Southern California Edison Company
SAN ONOFRE NUCLEAR GENERATING STATION
P O BOX 128
SAN CLEMENTE, CALIFORNIA 92672

Subject: Follow-Up Activities Associated with NRC-IIT Investigation
San Onofre Nuclear Generating Station, Unit 1

3. Proposed Facility Change (PFC)/Design Change Package (DCP) 1-85-3052.OTJ. Rev. 0 (Main Control Room Indication of Main Feedwater Low Flow)

Description PROVIDE MFW LOW FLOW INDICATION IN THE MCR TO ENHANCE OPERATOR ADMINISTRATIVE CONTROL TO PREVENT WATER HAMMER WHEN THE FEEDRING IS UNCOVERED.

DCP# 3052.0TJ REV 0 SHT 75 OF 210

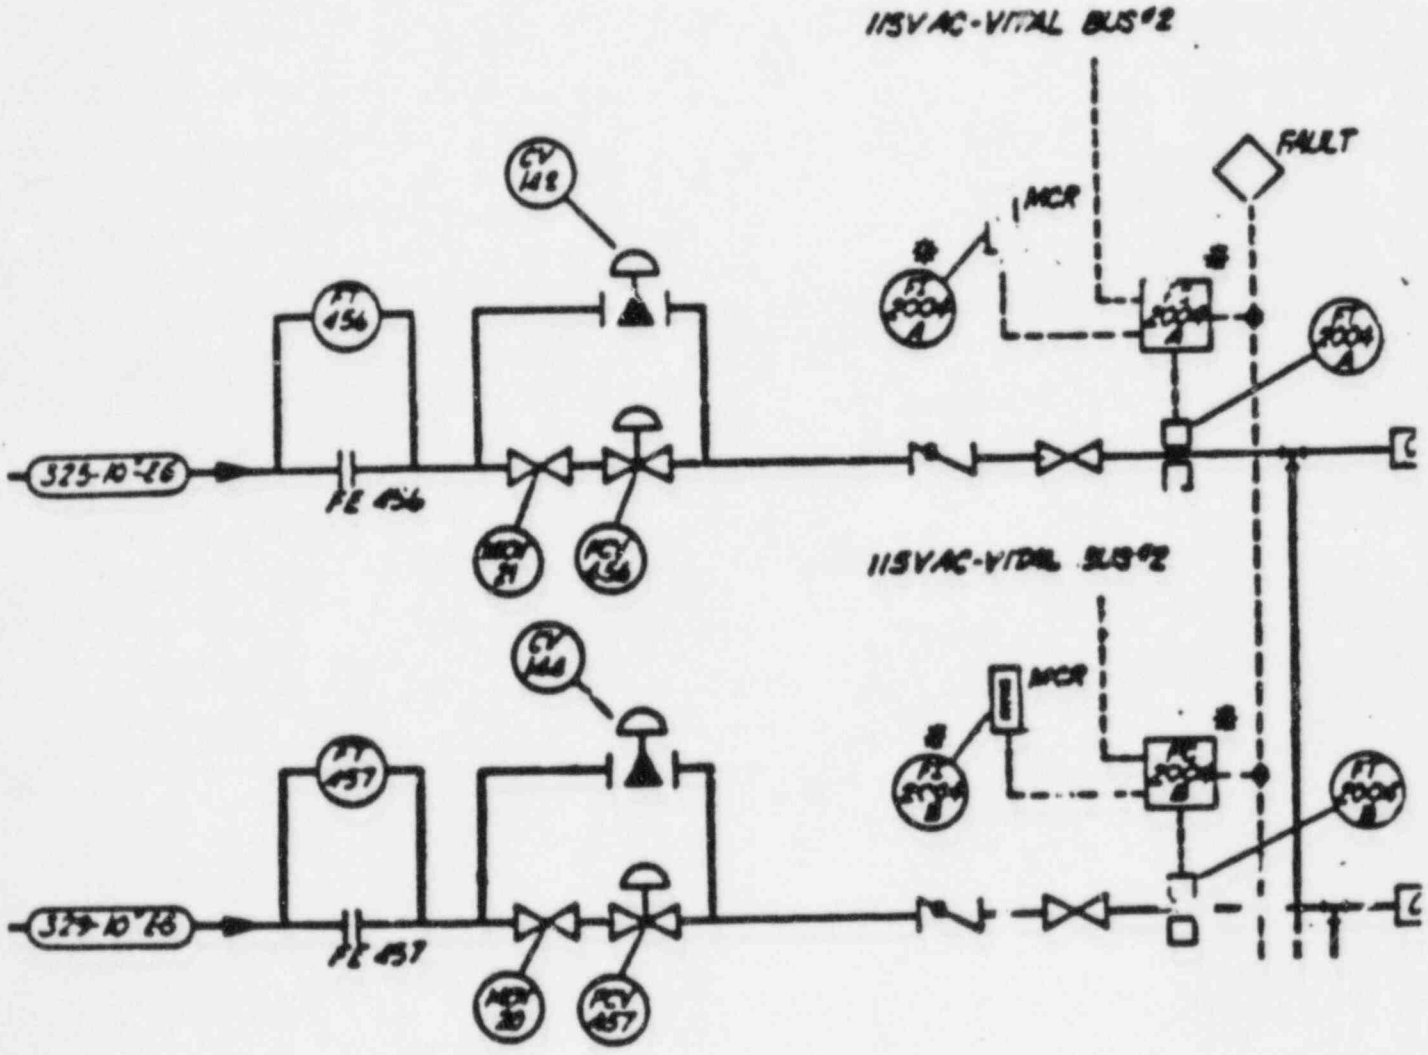
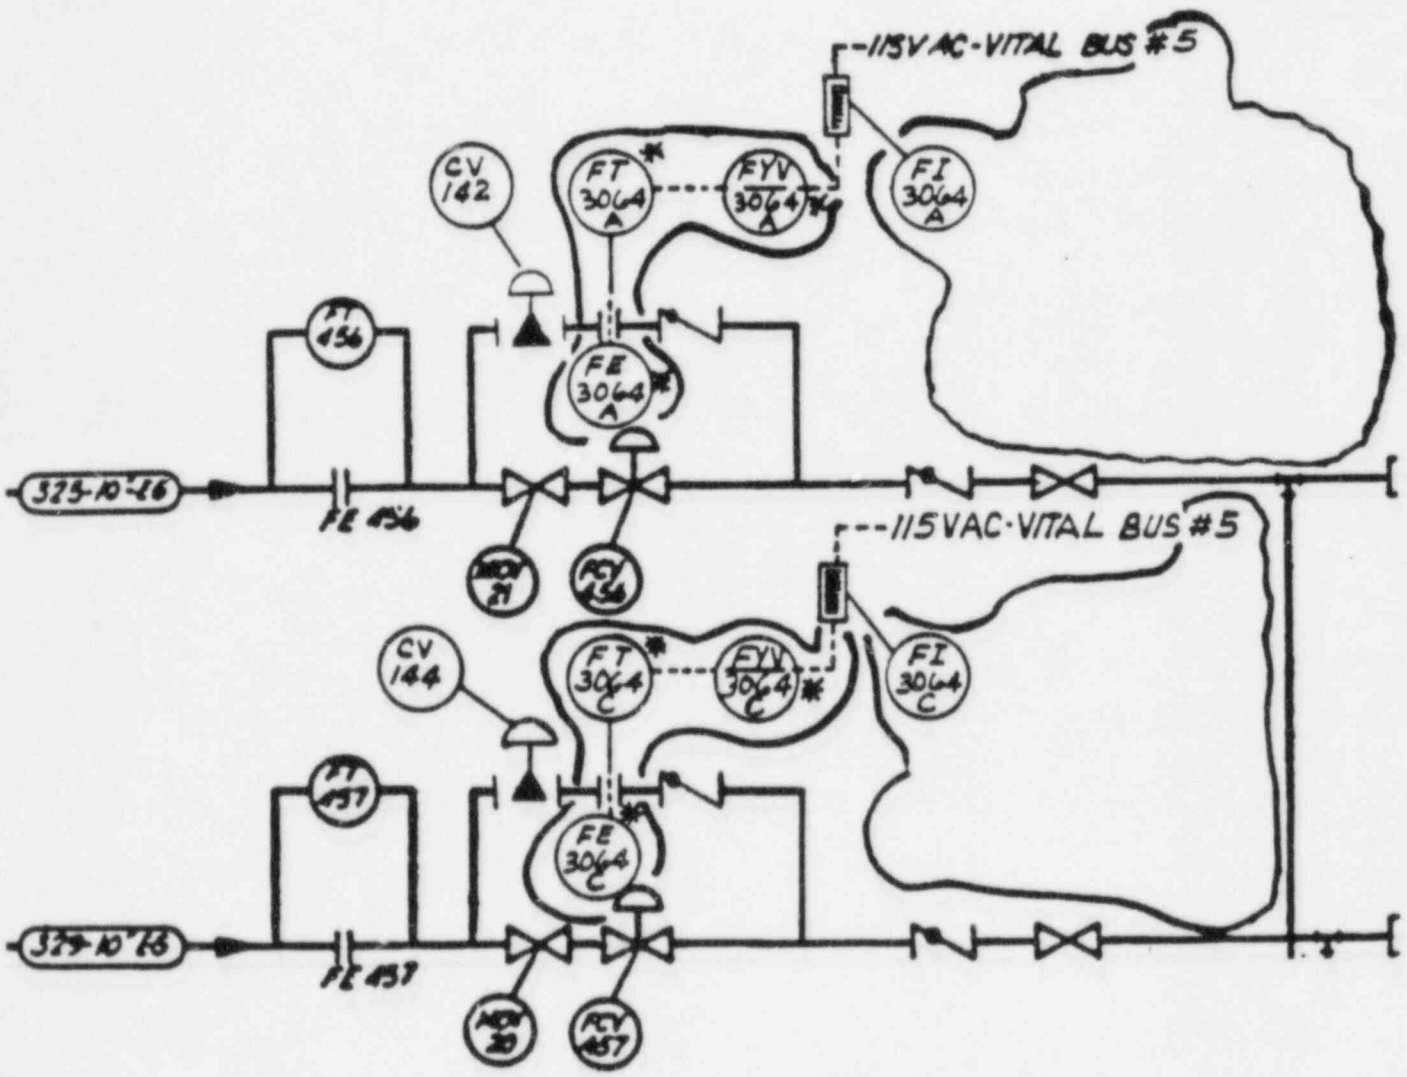
REVISE DRAWING 451283 TO ADD MFW LOW FLOW INDICATION

DCP# 3052.0TJ REV 0 SHT 8 OF 210

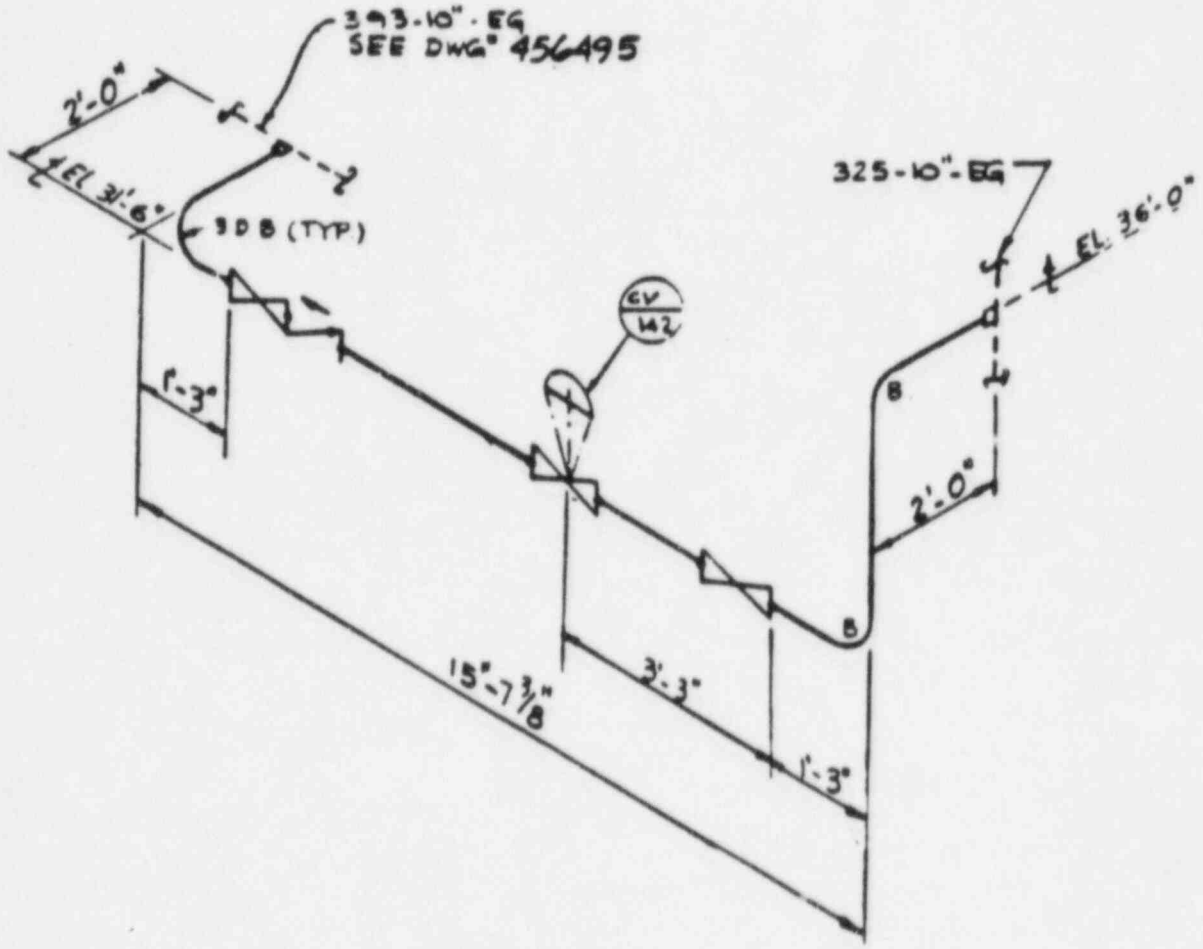
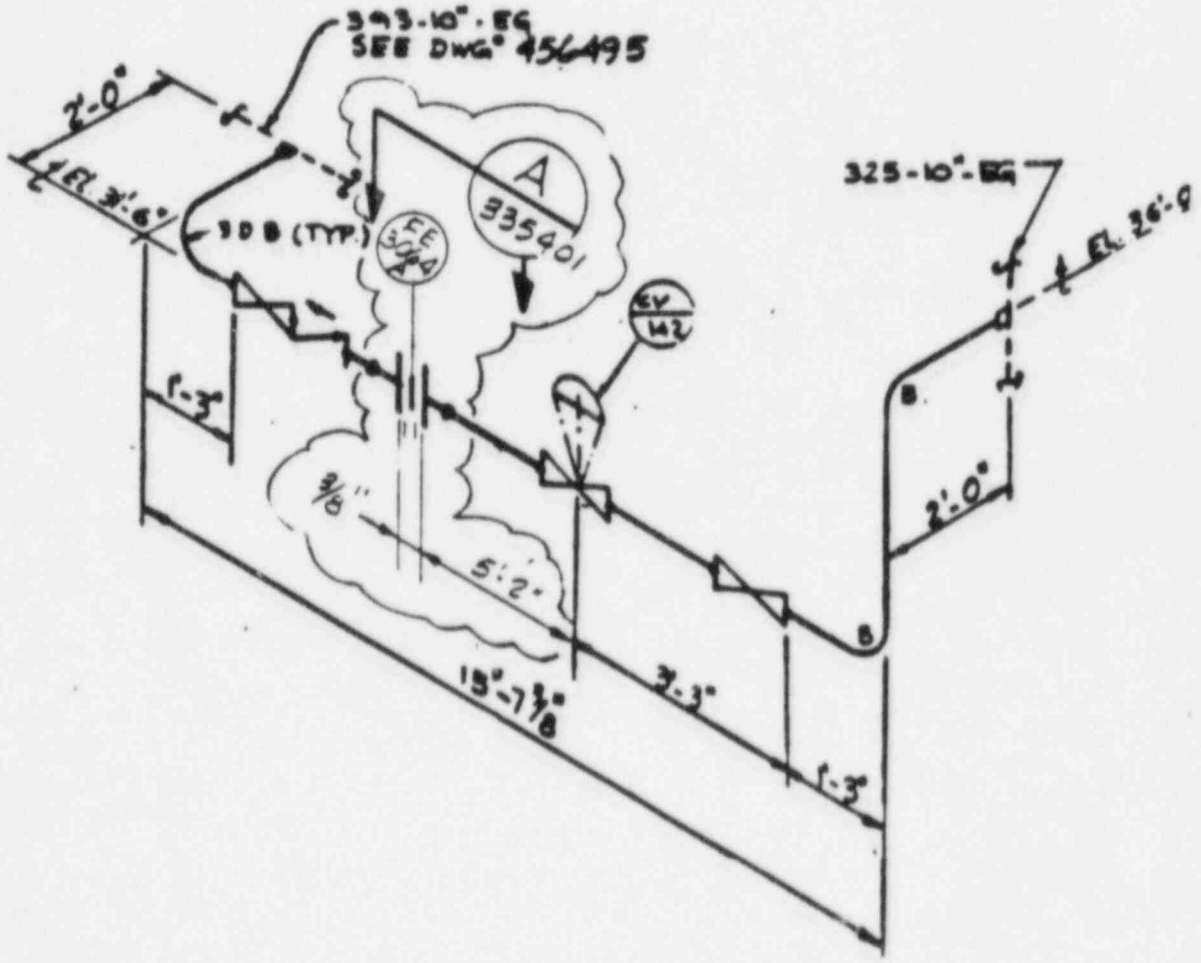
ADD ORIFICE FLANGES & ORIFICE PLATE 5'-2" DOWNSTREAM OF CENTER LINE OF CV-142.

AFTER

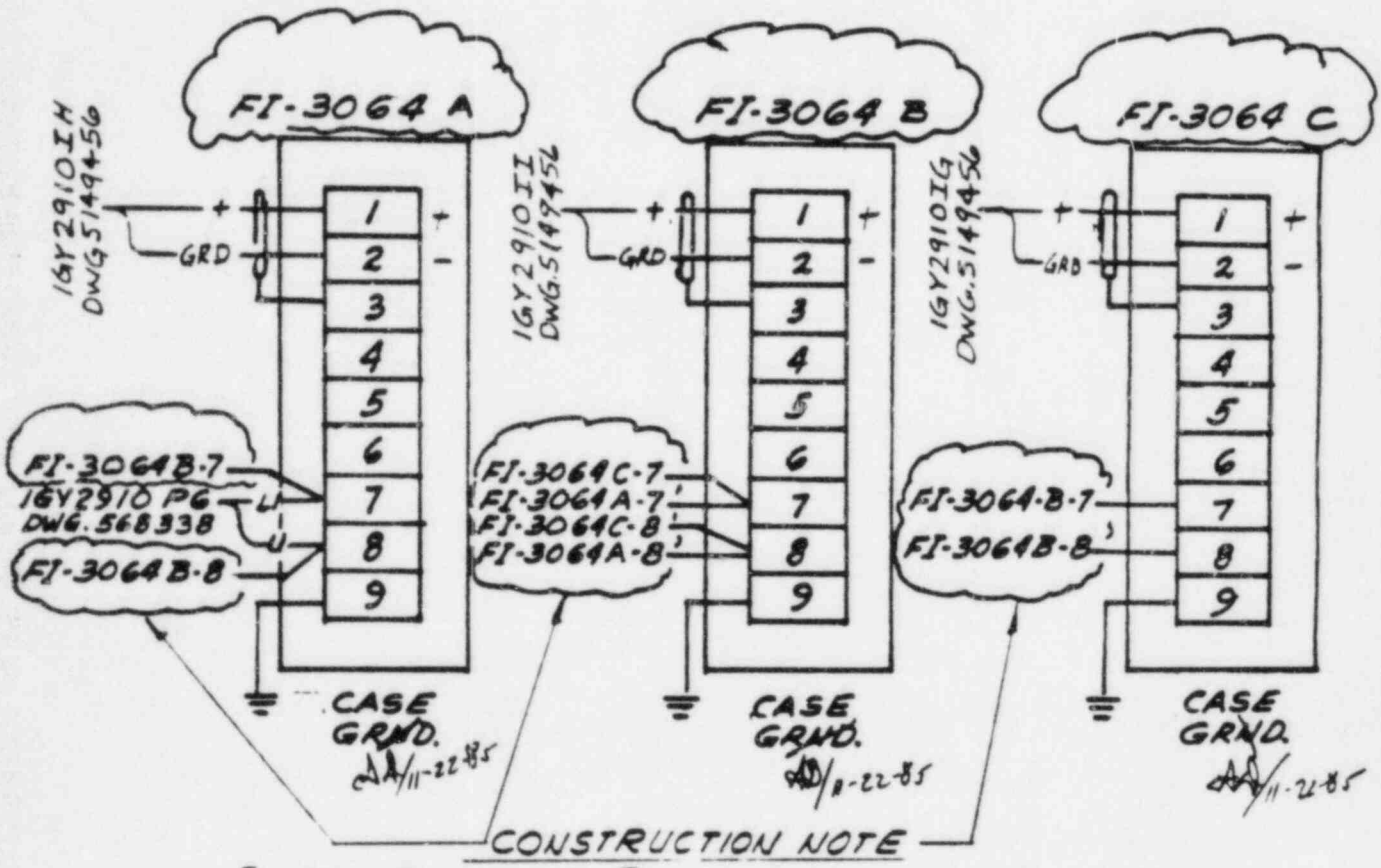
RE-DRAWN FOR CLARITY ONLY

DCP# 3052.01 REV 0 SHT 11 OF 21

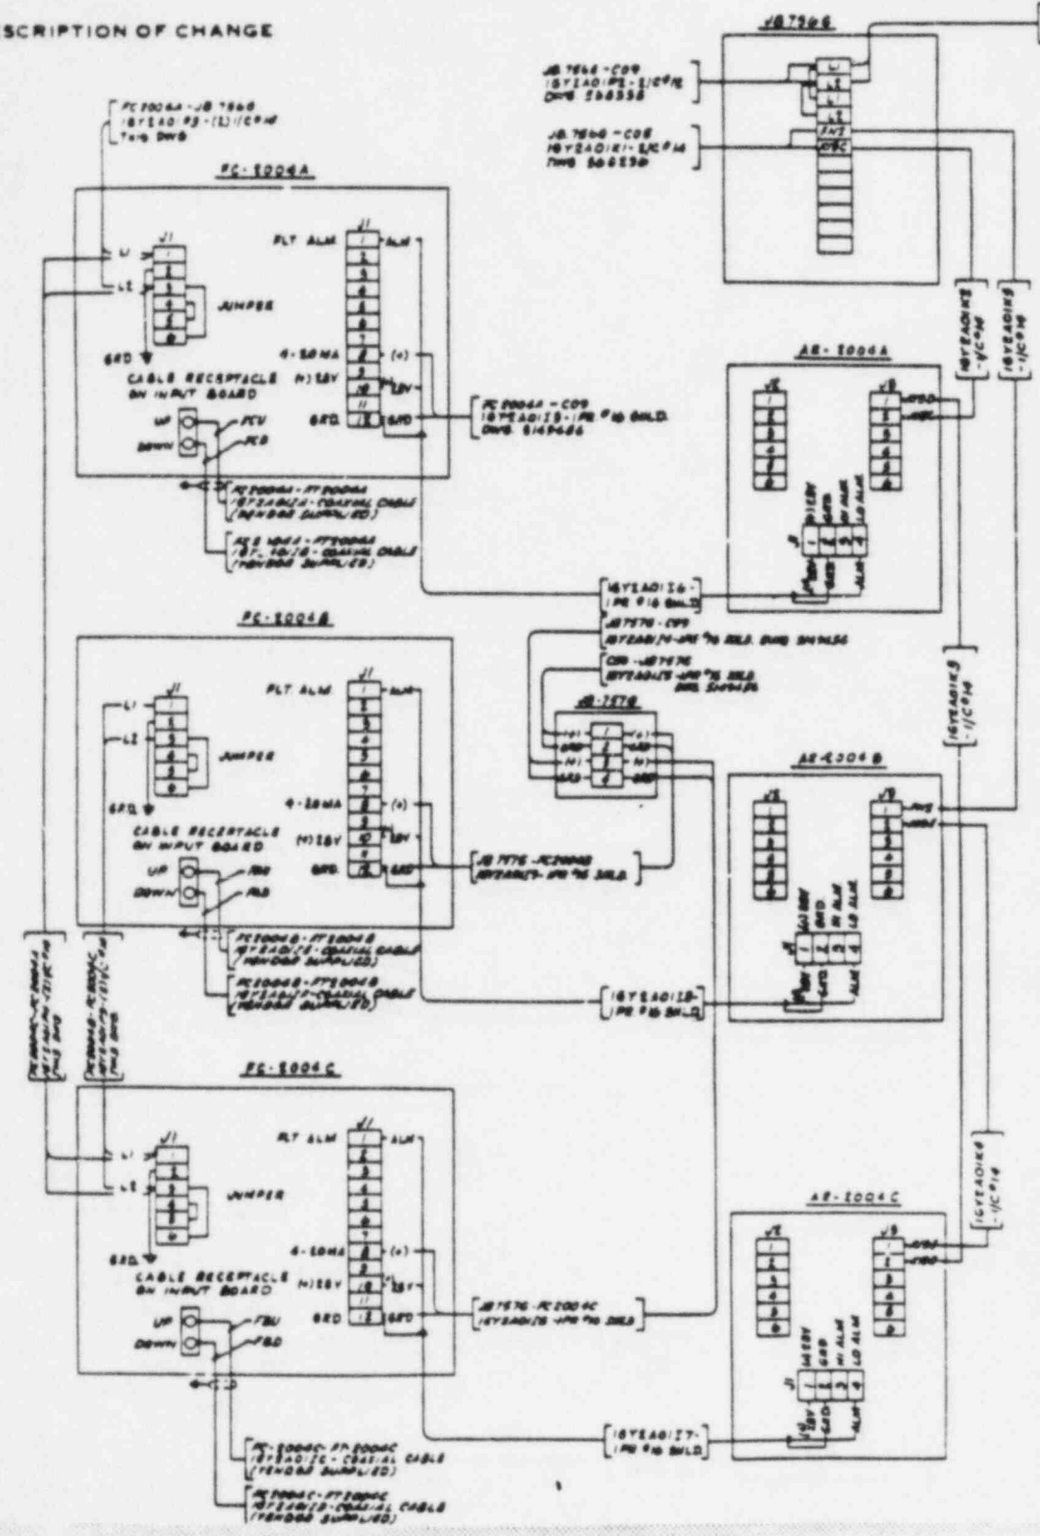
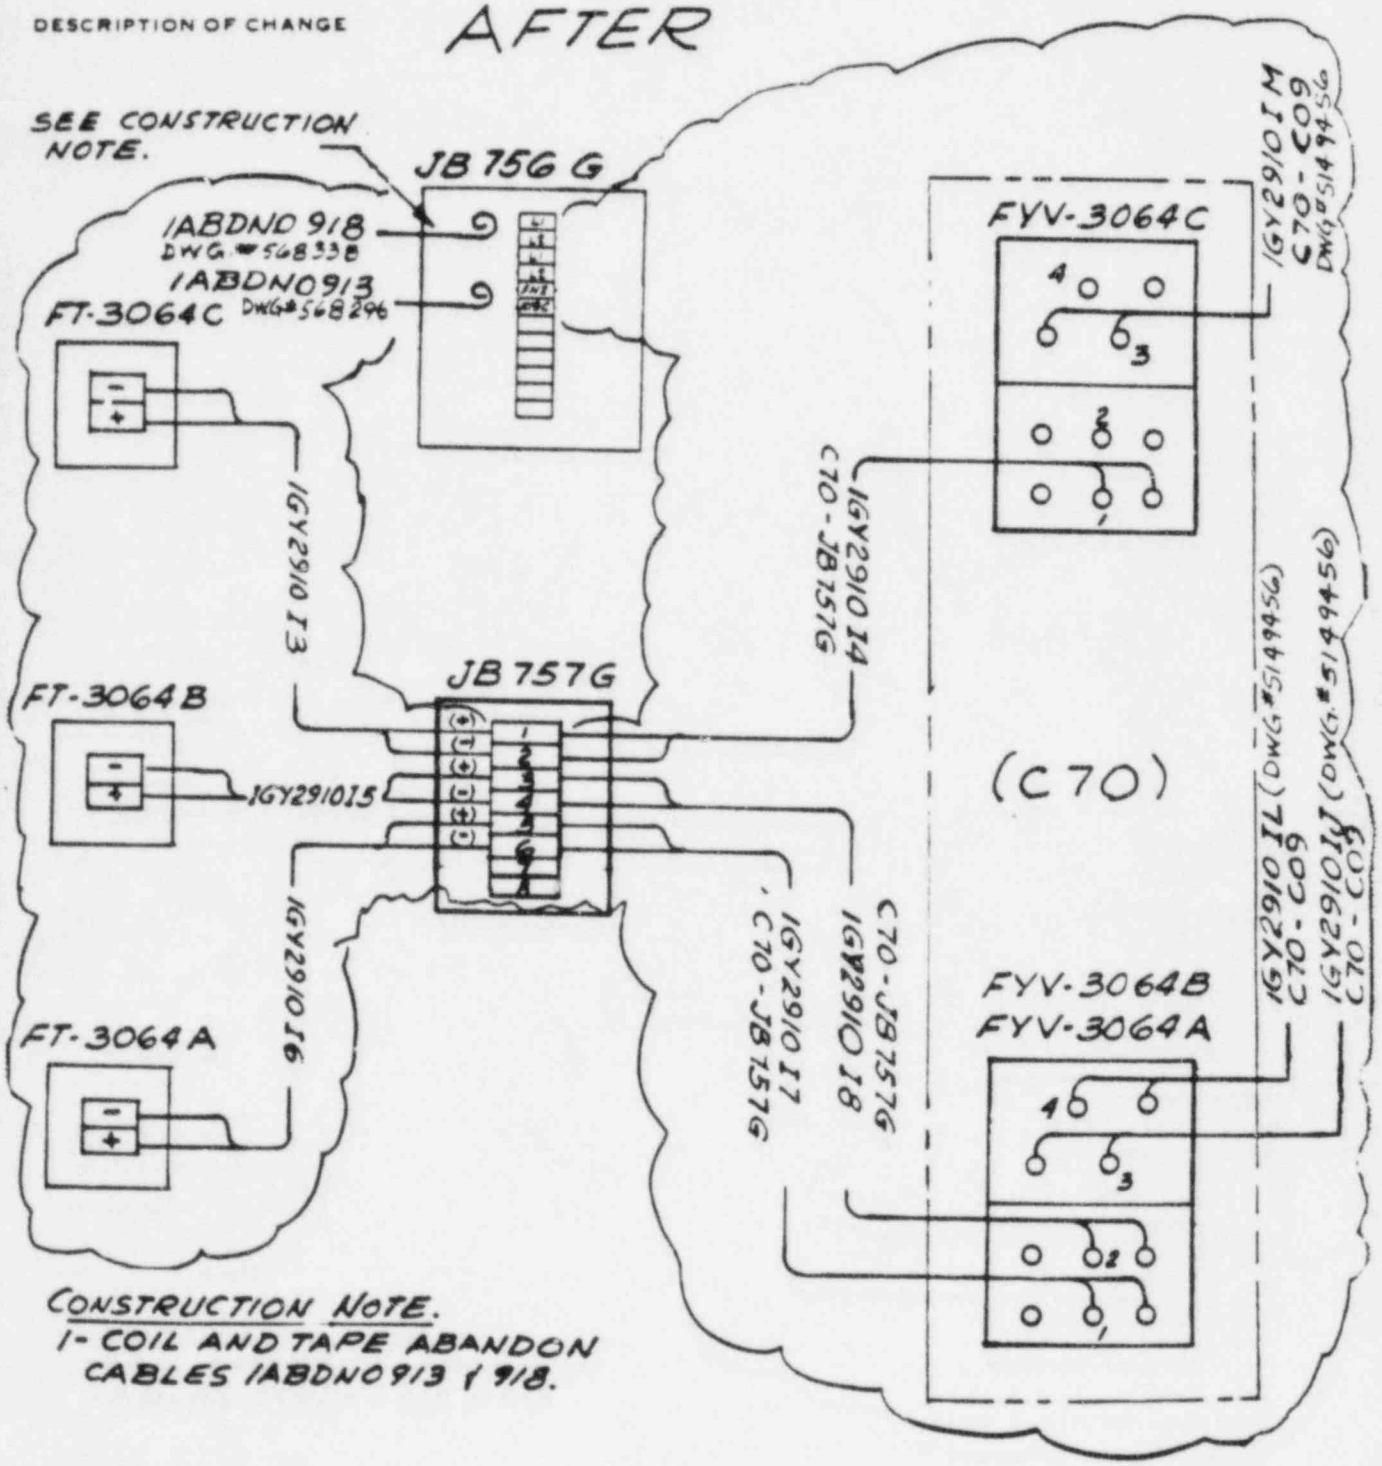
CONSTRUCTION NOTE.
1- COIL AND TAPE ABANDON CABLES 1ABDNO913 & 918.
